Customer Safety Advisory Notice

CAN 009-2016

Re: Biograph mCT and Biograph mCT Flow Light Marker Window

Figure 1

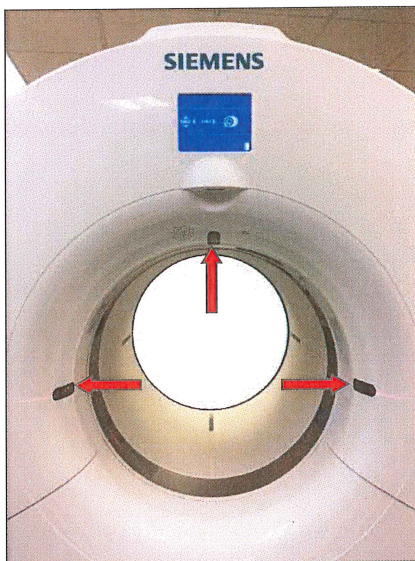
The light marker windows (see Figure 1) used for the positioning laser and integrated into the front cover of your Biograph mCT or Biograph mCT Flow system may loosen and potentially drop out. In this case there is a risk that a person could touch the electrical or rotating parts of the gantry in the unlikely event that they reach through the window opening. This could result in a serious injury such as, electrical shock or physical harm.

In the event that the light marker window is missing or loose, you should not use the Biograph mCT or Biograph mCT Flow and you should immediately contact your local Siemens Customer Service Engineer for correction of the problem.
